Project Name: Elizabeth Trace
 Description: Amended preliminary and final site plan approval
 Date on Agenda this packet pertains to: March 6, 2025

RE: Elizabeth Trace- Preliminary and Final Site Plan Review – 2nd Review

**Combined Preliminary – Final Site Plan Review
for
White Lake Charter Township, Michigan**

Preliminary and Final Site Plan Review

Existing Condominium Building

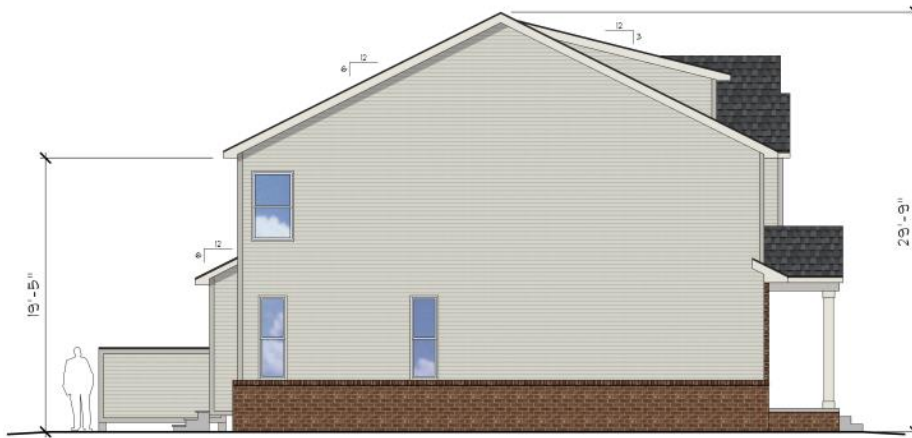
1. The amount of brick on the rear, and side elevations should be comparable with the existing buildings.

- 1) *Recommendation that the brick coverage on the rear, and side of the proposed elevations should be comparable to the existing buildings.*

OVERALL PLAN

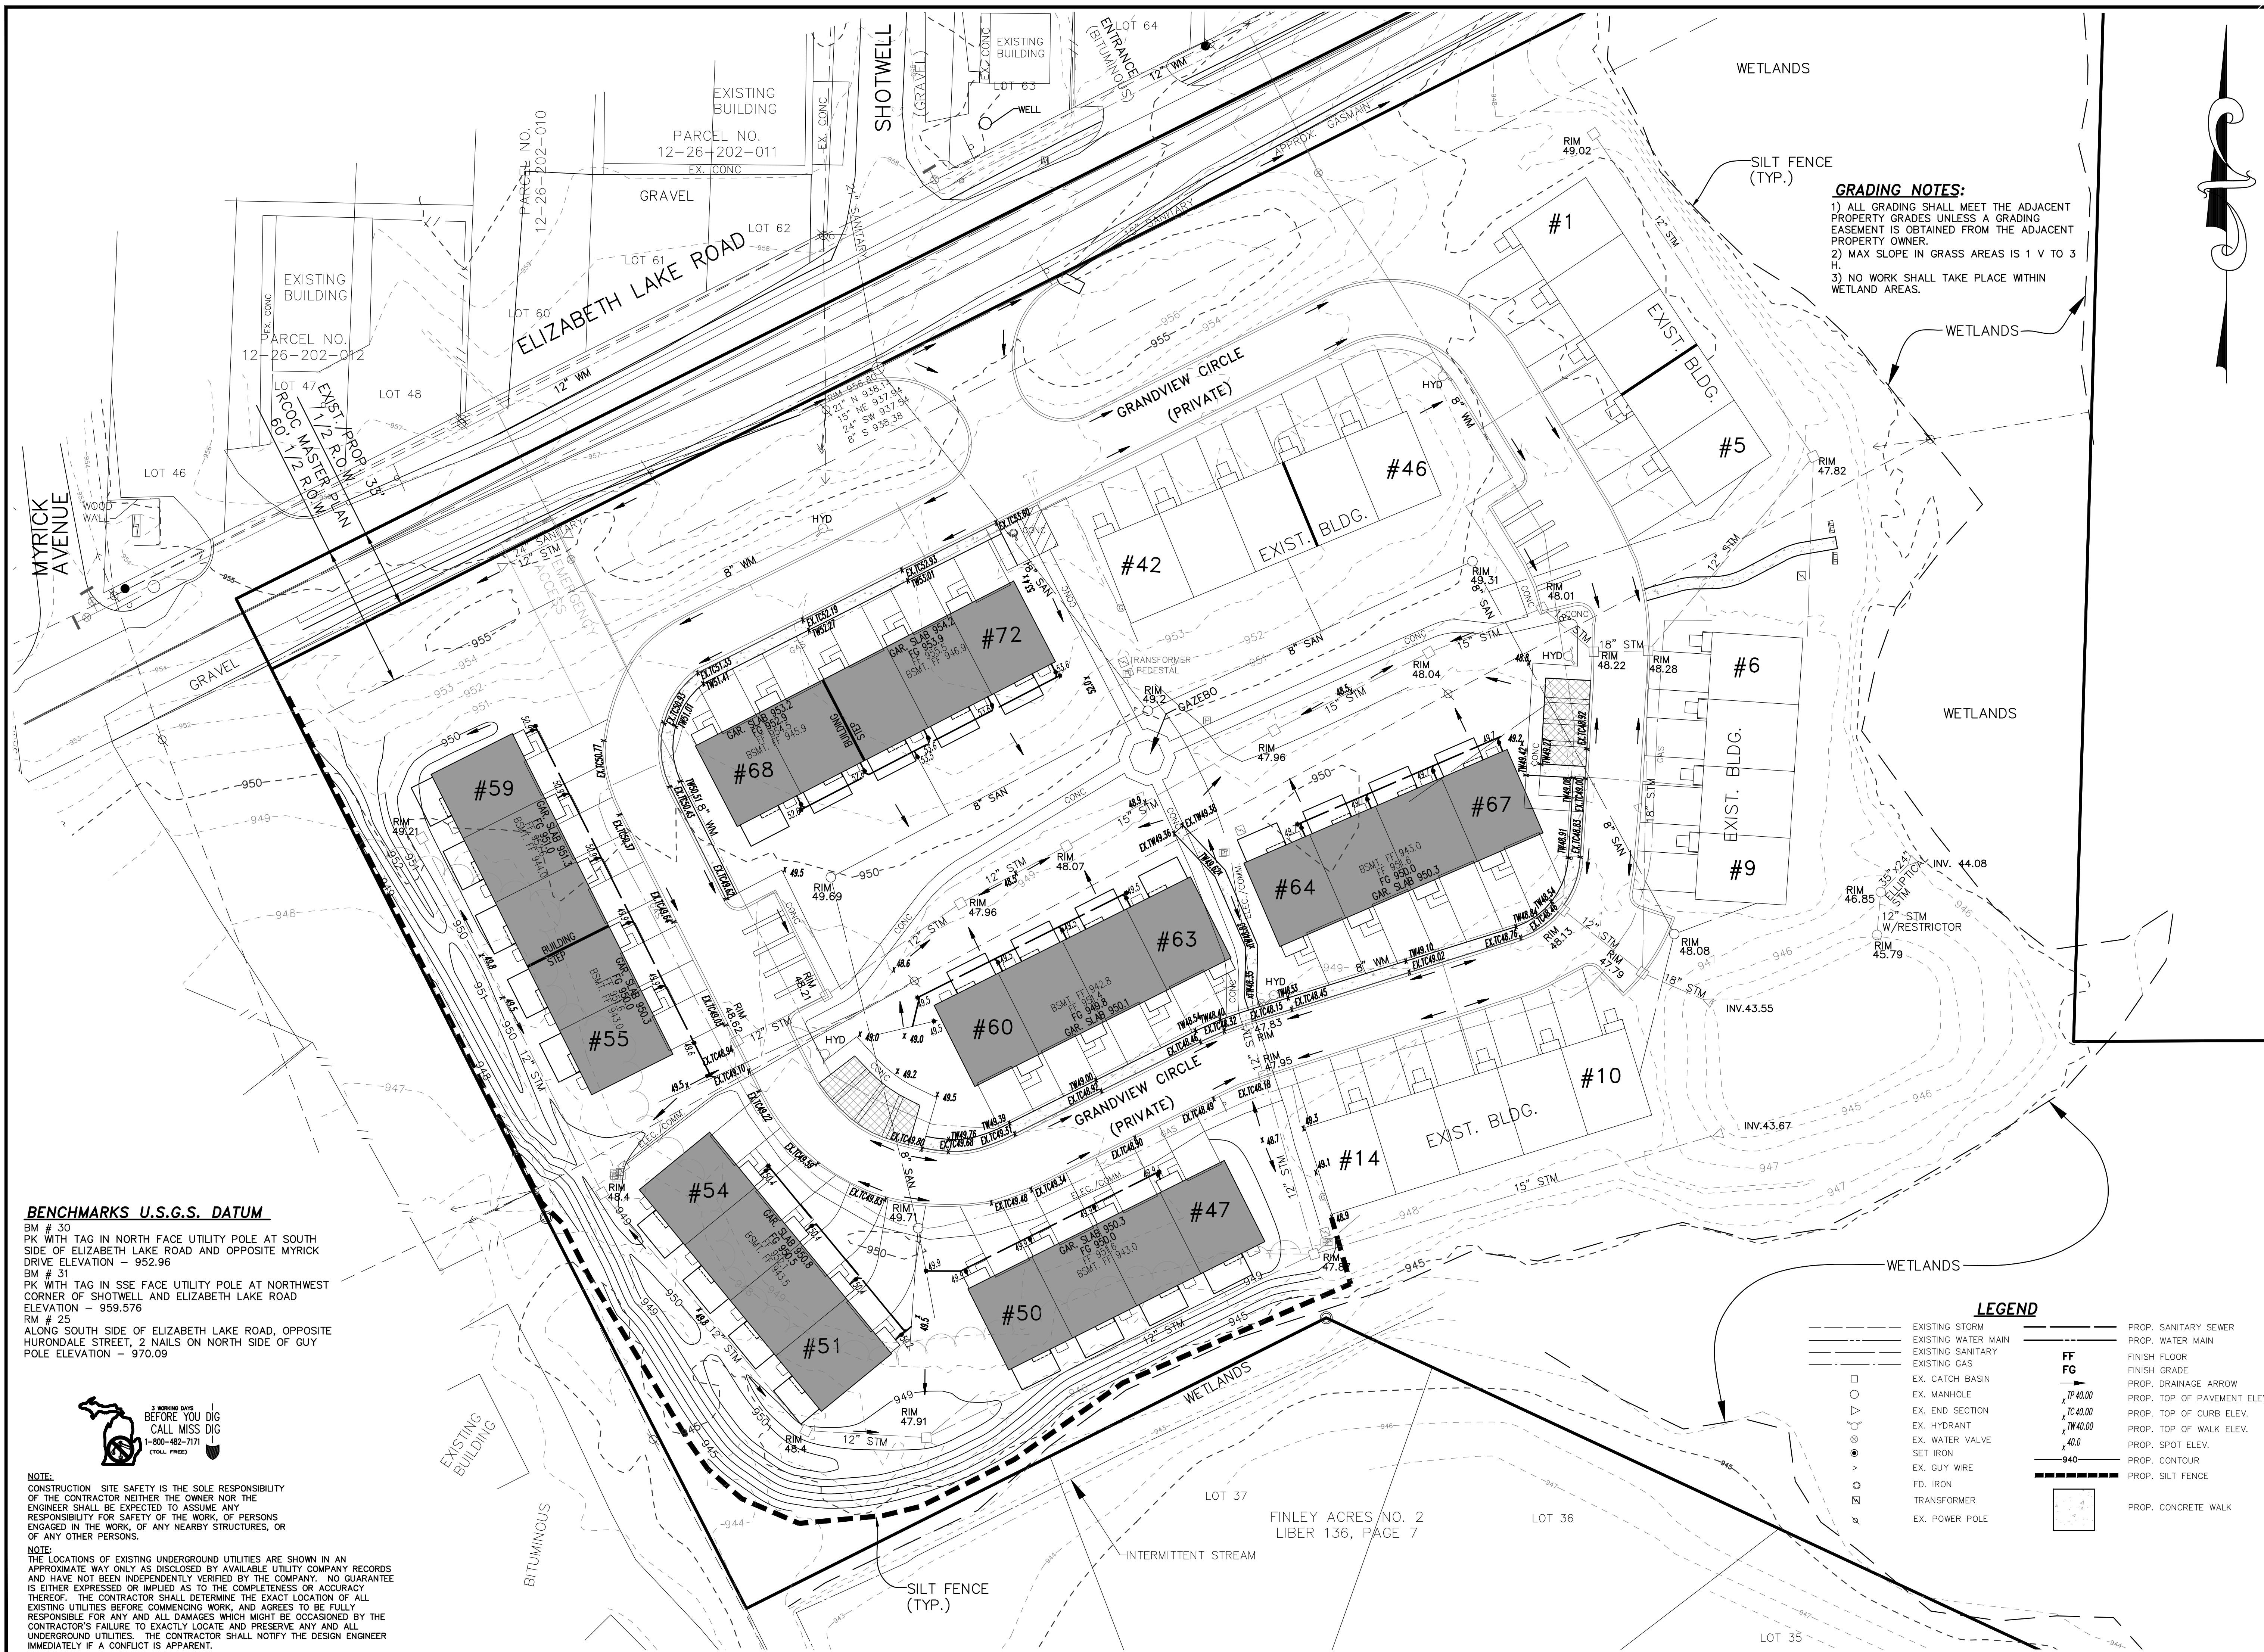
As stated in the Natural Features portion of this review, Section 3.11.Q states no building or structure shall be located closer than twenty-five (25) feet to any regulated wetland, submerged land, watercourse, pond, stream, lake or like body of water. Per Sheet 1, units 47 through 50 are permitted, but the patios are not.

Units 50 and 51's driveways are over the 20' wide easement for sanitary sewer as shown On Sheet 1. Unit nine's driveway also encroaches the easement, however this is an existing unit.

views indicate no site lighting is utilized in the existing portion of the site. A note should be added to Sheet 1 stating no site lighting is proposed for phase 2.

- 1) *A note should be added to Sheet 1 indicating no site lighting is proposed.*

CLIENT: PH HOMES
GRADING PLAN
ELIZABETH TRACE SITE PLAN AMENDMENT
RANGE: 8 E
TOWNSHIP: 3 N
WHITE LAKE TOWNSHIP
OAKLAND COUNTY
MICHIGAN
SECTION: 26

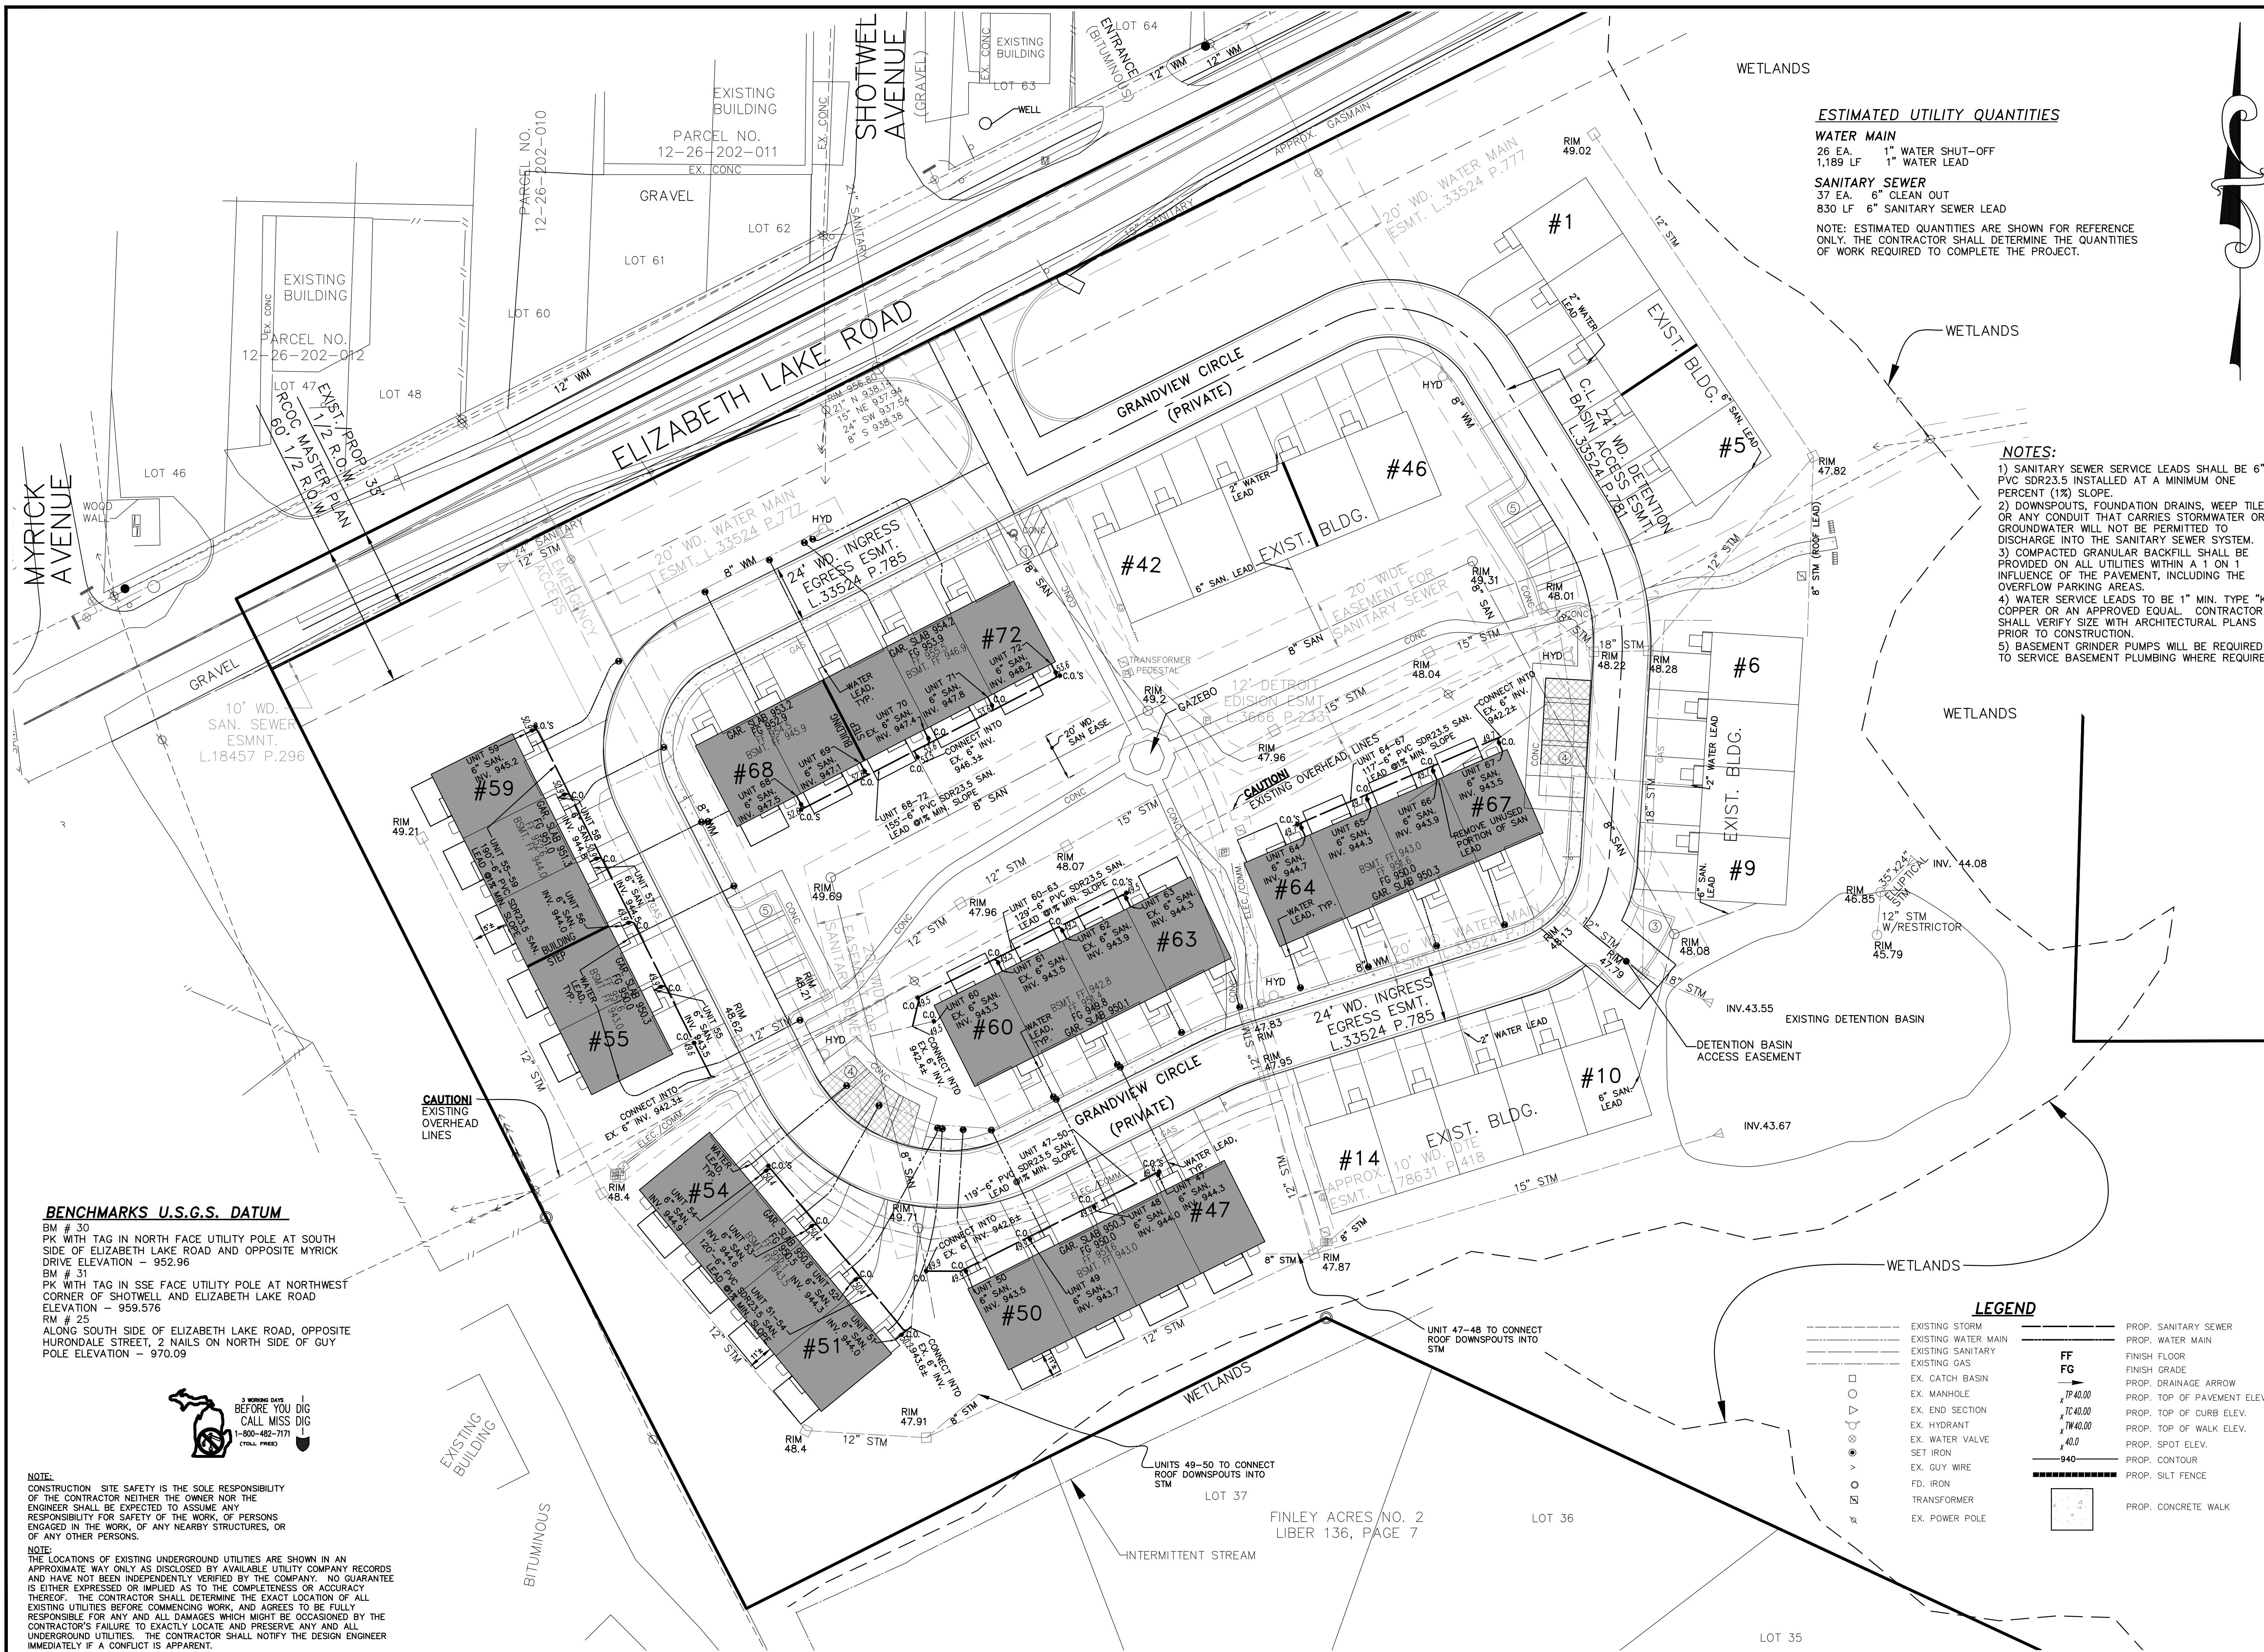
- i) *The grading was reviewed for general conformance with Township requirements. A more detailed review shall be conducted on the Final Engineering Plan. **Comment remains.***

Topography: Sheet 2 shows the existing site topography and the proposed grading plans. The entire site is relatively flat, ranging from nine hundred and forty-five (945) feet in the southeast corner to nine hundred and fifty-six (956) feet in the northeast corner. We note that the proposed grading will move the dirt to the west side and southwest corner of the site, however extensive grading will not be required.

Landscape Plan

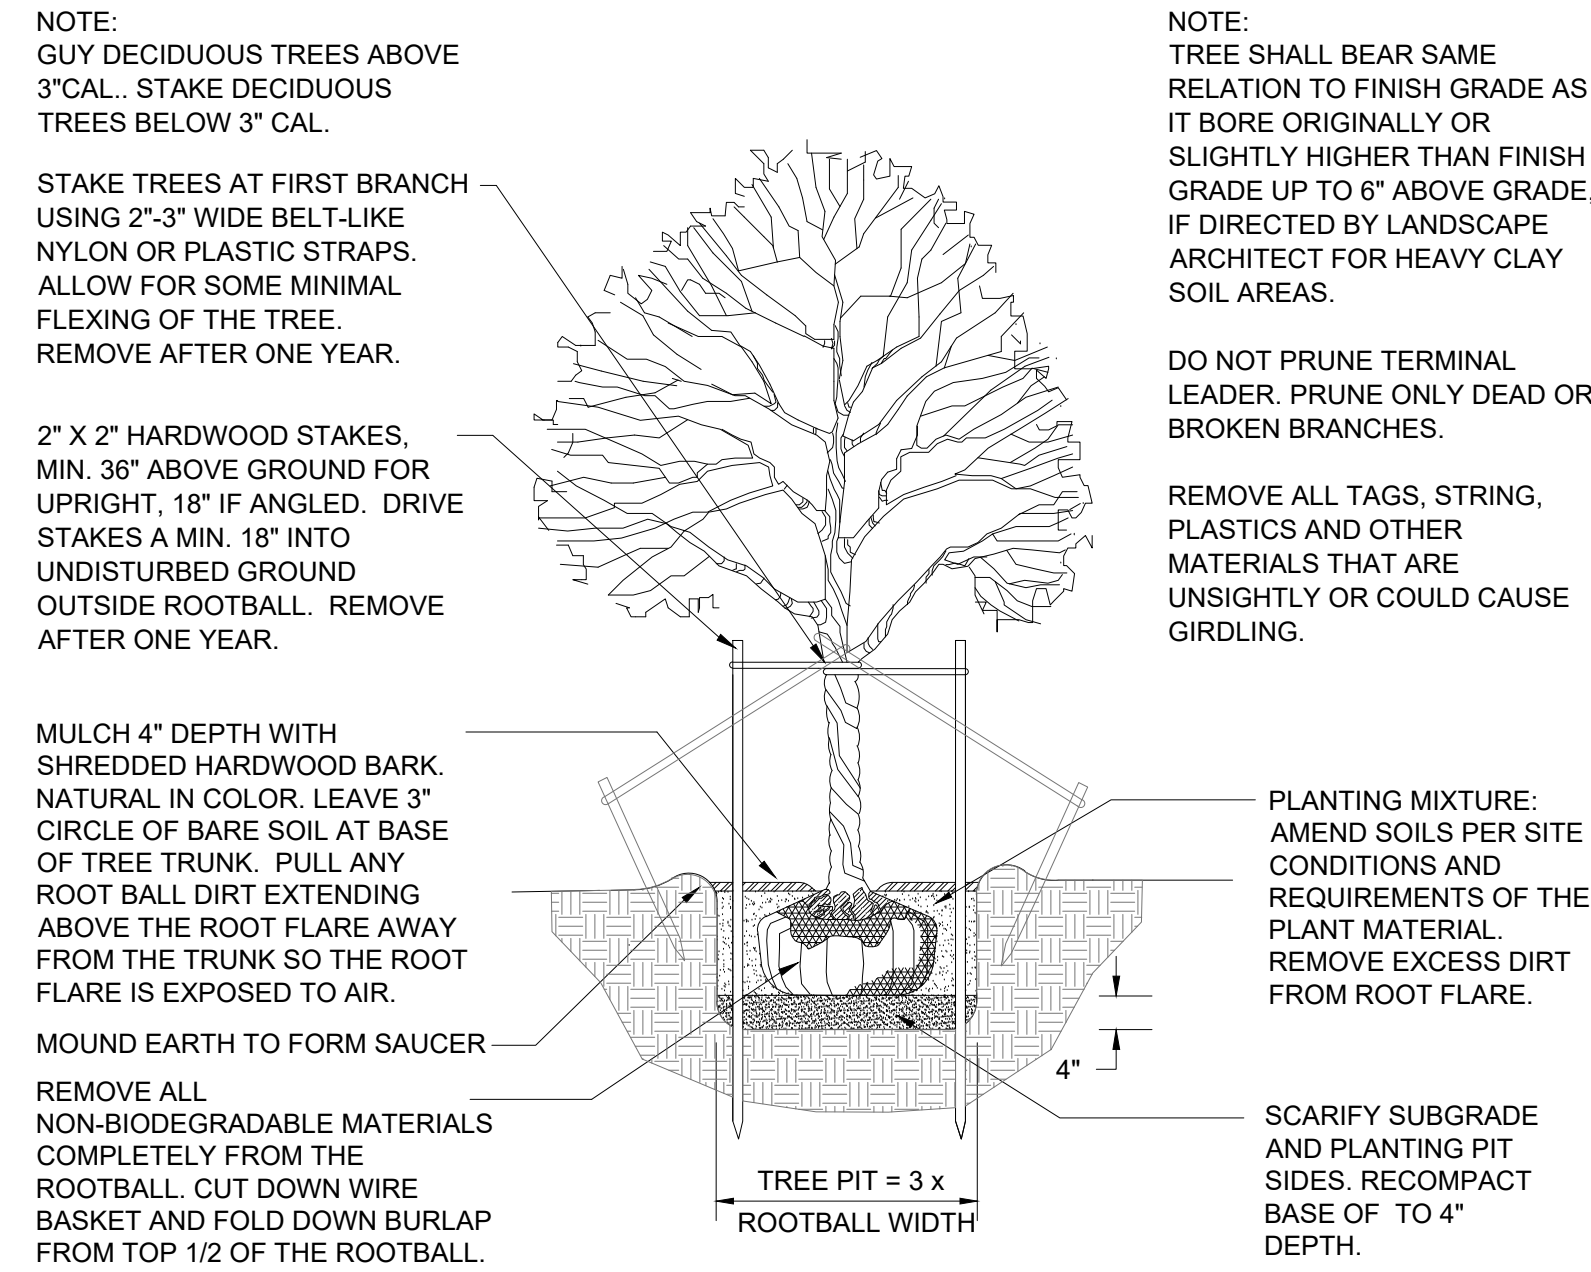
- j) *Sheet L-1- Proposed tree planting horizontal separation relative to water service leads shall be maximized. In addition, there are several areas where trees are proposed to be planted directly over water service lines (example Unit 61). Please relocate trees accordingly.*

- 1) *Notes on Sheet L-1 should be updated to show the correct total lot area requirements.*
- 2) *Planning Commission to consider waiver to allow for proposed greenbelt landscaping.*
- 3) *Planning Commission to consider waiver to allow for proposed interior landscaping.*
